**Request for Additional Information No. 276, Supplement 2**

**U. S. EPR Standard Design Certification**

**Docket No. 52-020**

**SRP Section: 11.05 - Process and Effluent Radiological Monitoring**

**Figure 11.05-13-1—Increase in Airborne Particulate Concentration at the U.S. EPR Radiation Monitor Sampling Location at 50 min after Increase in RCS Leakage Rate by 1 gpm [ANSI/ANS 18.1 RCS Radionuclide Mix]**

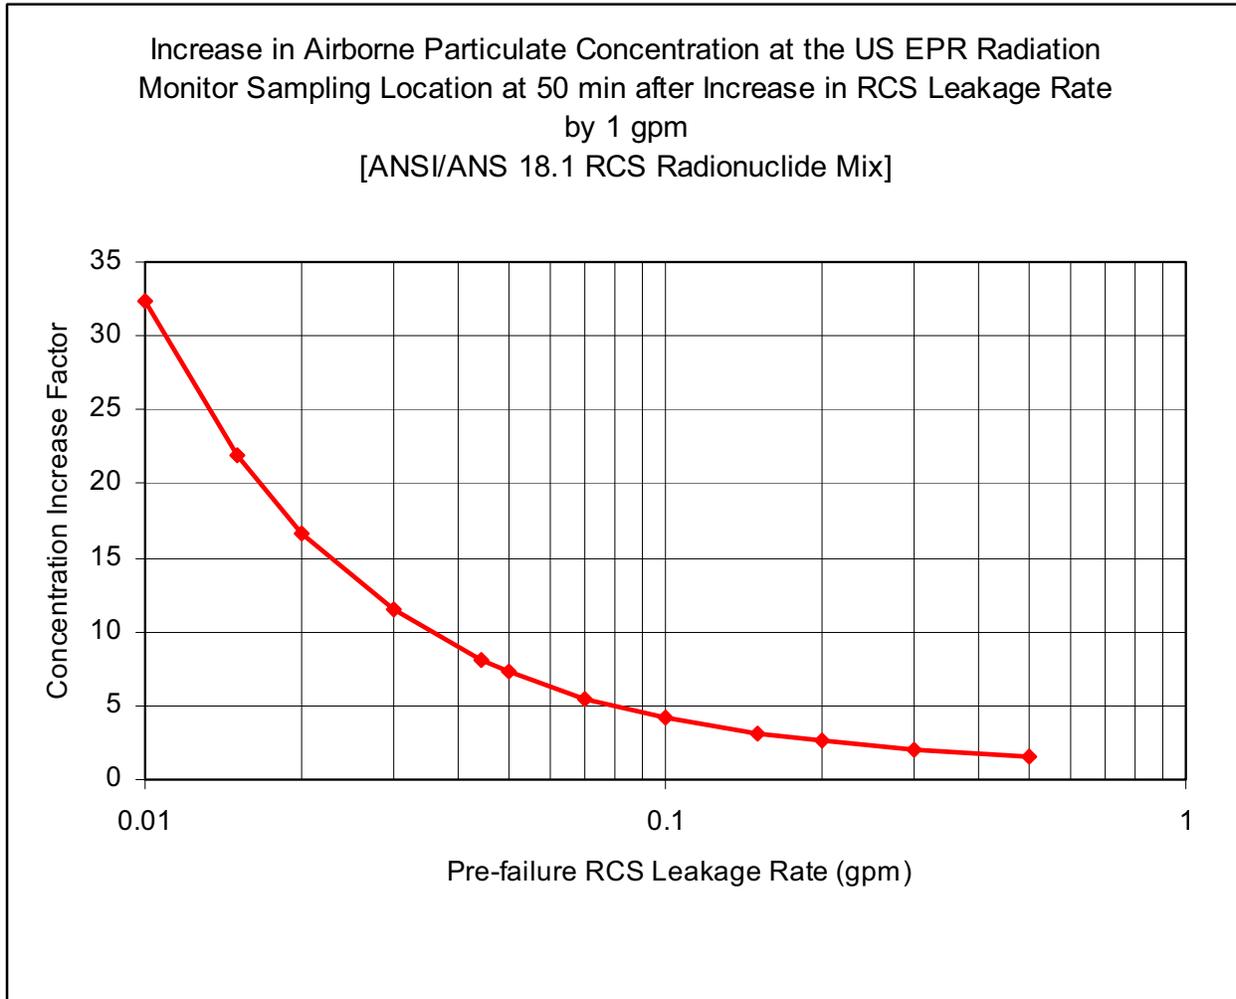
FSAR Sections 11.5.1.2 and 5.2.5.1.2 address instrumentation and methods used to quantify reactor coolant system leakage and leakage rates, as required by EPR Technical Specifications (TS) 16.3.4.12 and TS B16.3.4.12. The technical basis for RCS leakage detection instrumentation [see (TS) 16.3.4.14 and TS B16.3.4.14, RG 1.45 (Rev. 1), and RIS 2009-02 (Rev. 1)] establish radiation monitor sensitivity requirements for a leakage detection increase of 1 gpm within 1 hour, using a realistic primary coolant concentration. A review of Sections 11.5.1.2 and 5.2.5.1.2 indicates that although Section 5.2.5.1.2 refers to Section 11.5 for information on the associated radiation monitoring instrumentation, Section 11.5.4 and Table 11.5-1 do not identify instrumentation and do not describe the methodology that would be used by COL applicants to monitor containment atmosphere for the presence of radioactive particulates capable of satisfying the requirements of EPR TS 16.3.4.12 on RCS leakage rates. Accordingly, the applicant is requested to review and revise Section 5.2.5 and 11.5 and address the following in the FSAR:

- b. In Section 11.5.2, provide the methodology to demonstrate that particulate radiation monitors will be capable of satisfying the technical basis for RCS leakage detection instrumentation using a realistic radioactive concentration in the RCS. Include descriptions of the model, methodology, assumptions, and parametric values used in the calculations and their basis, and references to enable the staff to conduct an independent evaluation.

- a. The increase in the airborne concentrations (at 50 minutes) for the individual particulate varies between 4.5 (for Rb-88) and 14.7 (for Te-129).
- b. The overall increase in the radiation monitor reading in 50 minutes (by a factor of 8.10) increases monotonically with time until new equilibrium conditions are attained, at which time the increase in the reading would be the same as the increase in the leakage rate (i.e., equal to  $1.0442 / 0.0442 = 23.62$ ).

- c. The increase in the monitor reading is a strong function of the initial RCS leakage. For informational purposes, the monitor reading increase (in 50 minutes) due to a one gpm increase in the initial leakage is shown in Figure 11.05.13-1.
